Town of Manlius

Planning Board Agenda

November 22, 2021

4. Keplinger Freeman Associates, LLC - 6320 Fly Road, East Syracuse, NY 13057 - Public Hearing - Site Plan And Subdivision - New Dental Office - 8195 Cazenovia Road, Manlius, NY 13104 - Tax Map # 114.00-01-15.10

SHEET NUMBER: L1.1

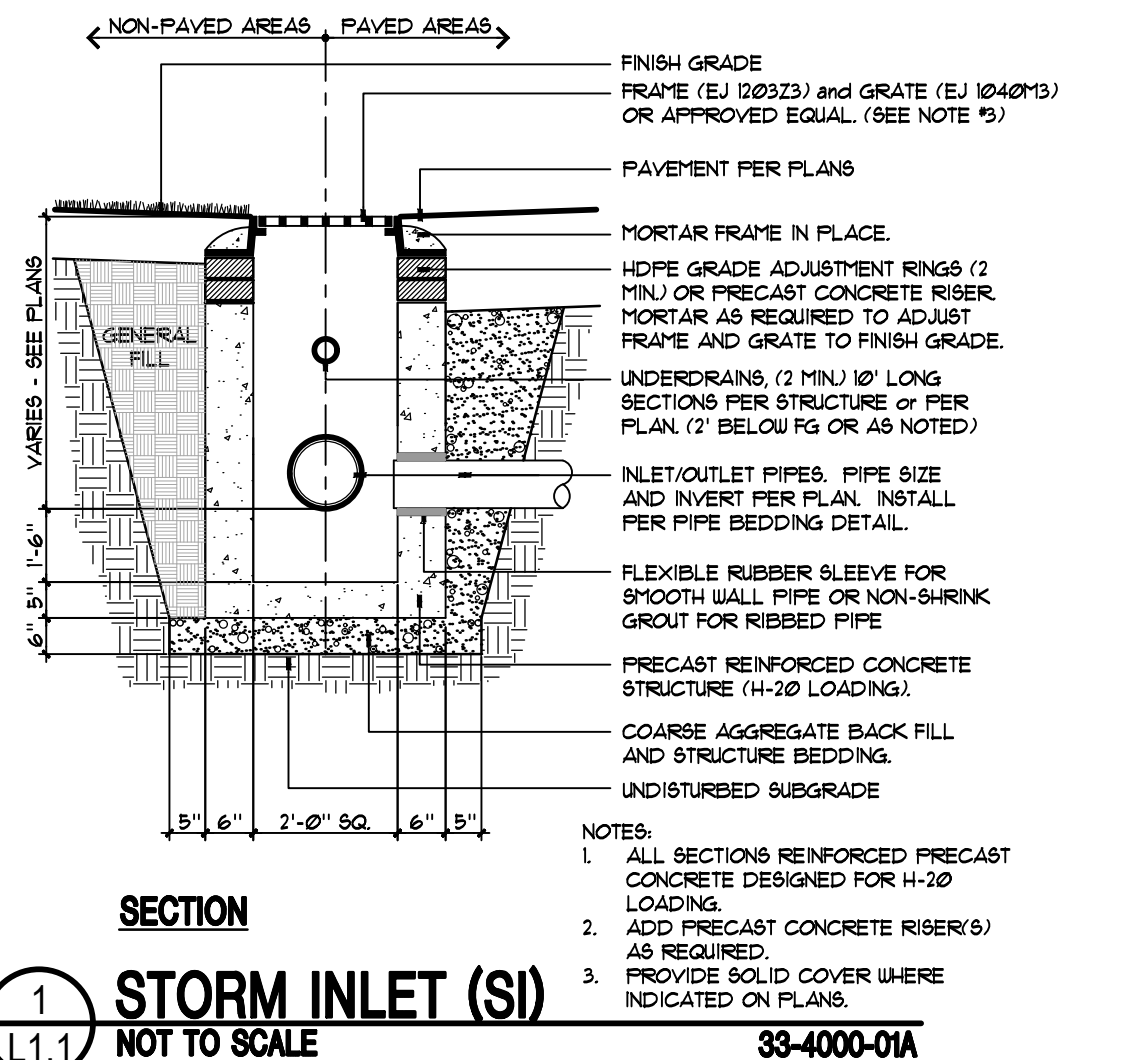
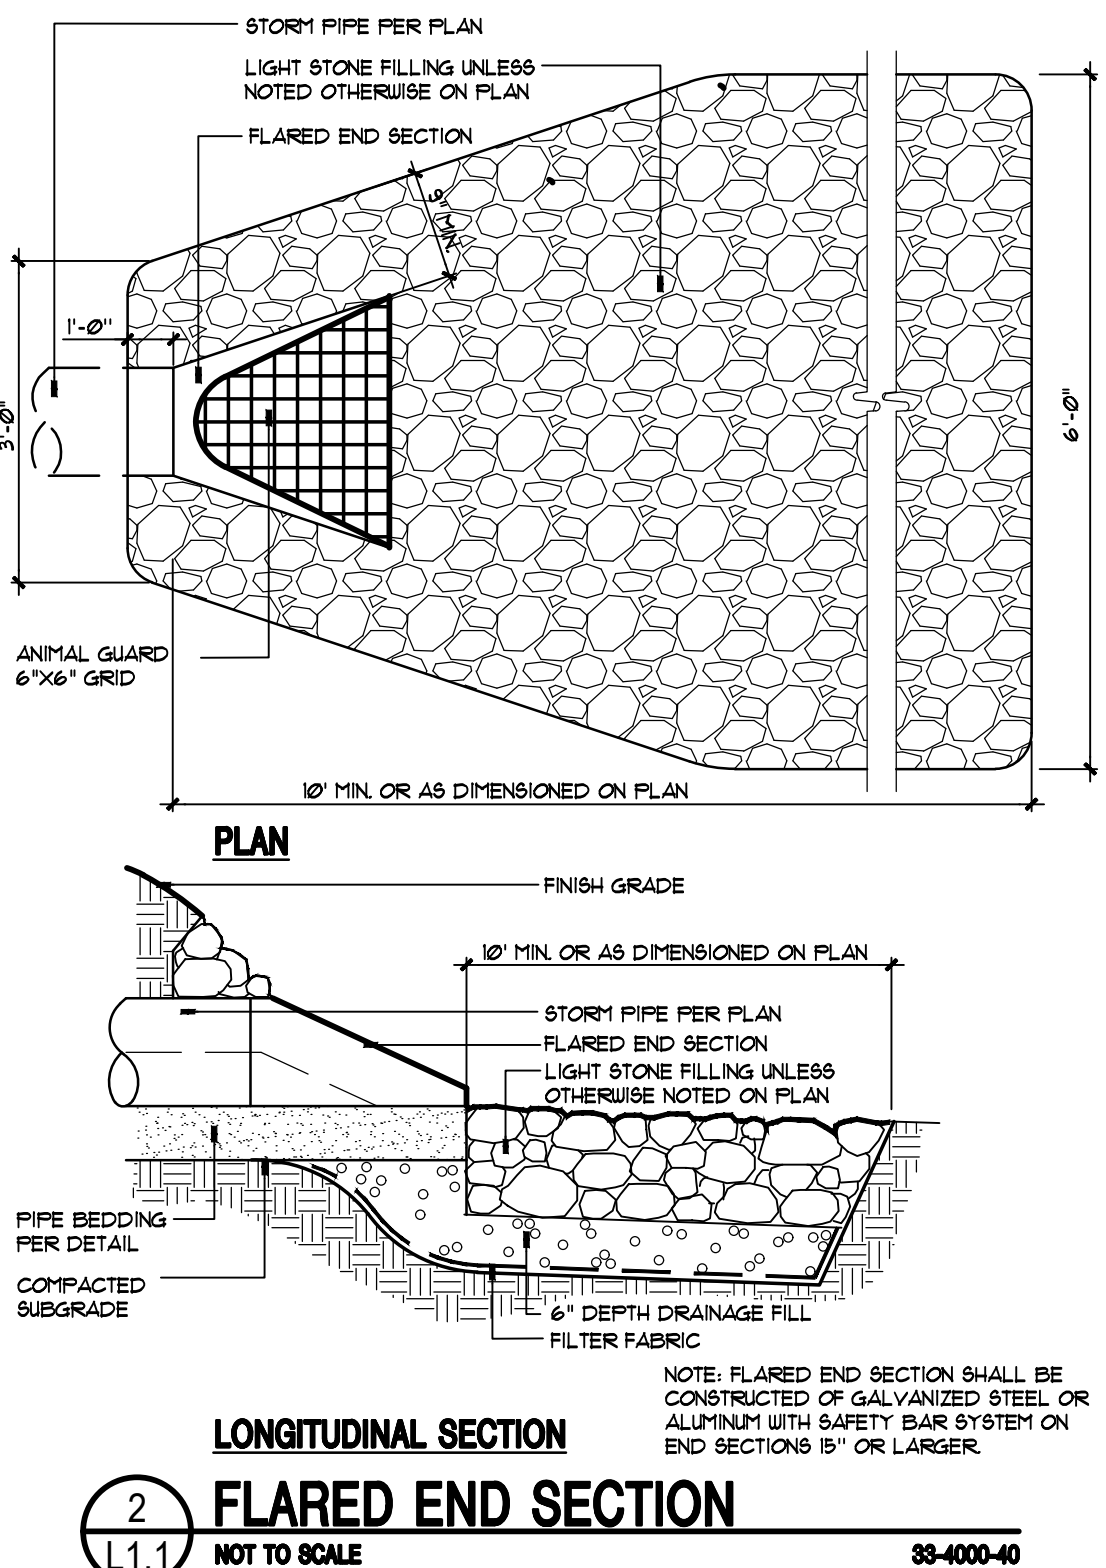
4. It needs to be noted in the report, and on the plans as well, that the owner is responsible for all required future maintenance of the stormwater facilities.

Response: Two test holes were dug in the area where the underground stormwater chambers are to be placed. No groundwater or bedrock were encountered. Refer to sheet L1.1 for test hole locations and soil information.

Response: A note has been added to sheet L1.1 and page 18 of the SWPPP Report, which have been included as part of this submission.

SECTION
1 L6.1 SC-740 ISOLATOR ROW DETAIL TYP.
NOT TO SCALE

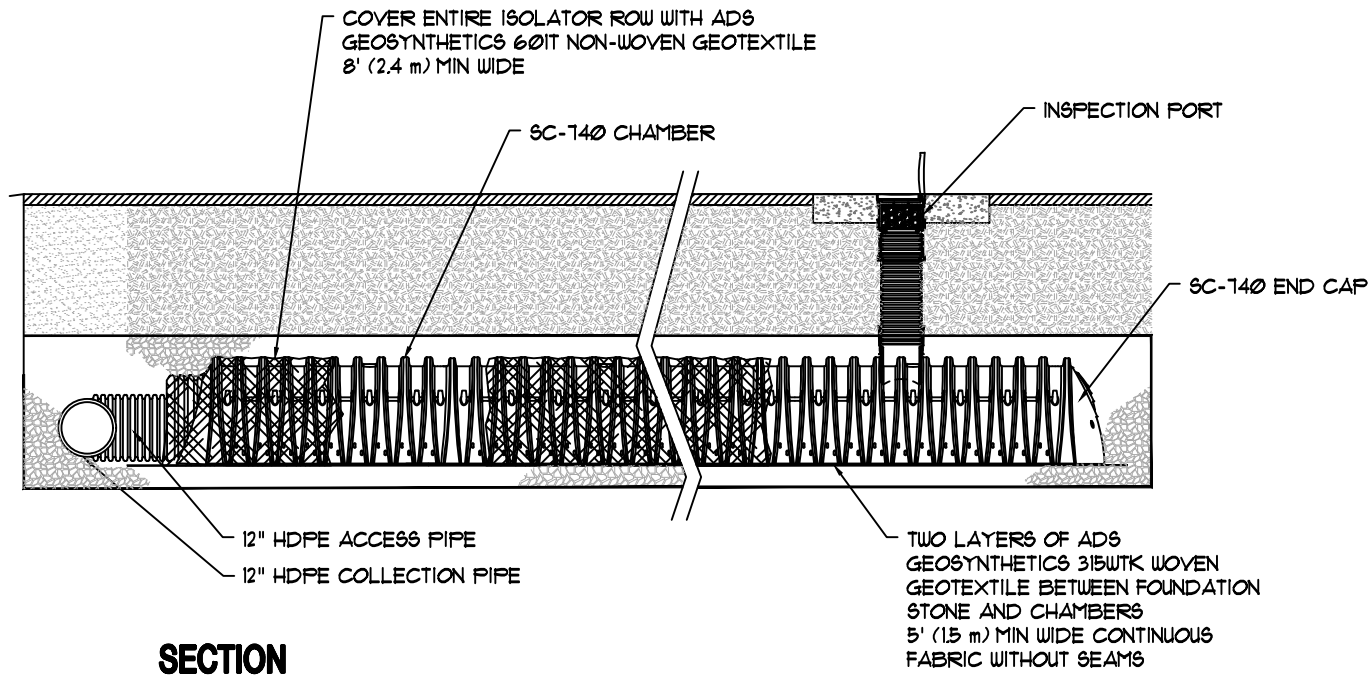
2. Related to the comment above, the system cross section needs to be updated to reflect proposed conditions and an elevation needs to be provided.

Response: The cross section for the SC 740 stormtech chamber system (detail 10/L5.1) has been updated. A profile for the SC 740 stormtech chamber system has been added to sheet L6.1 (1/L6.1).
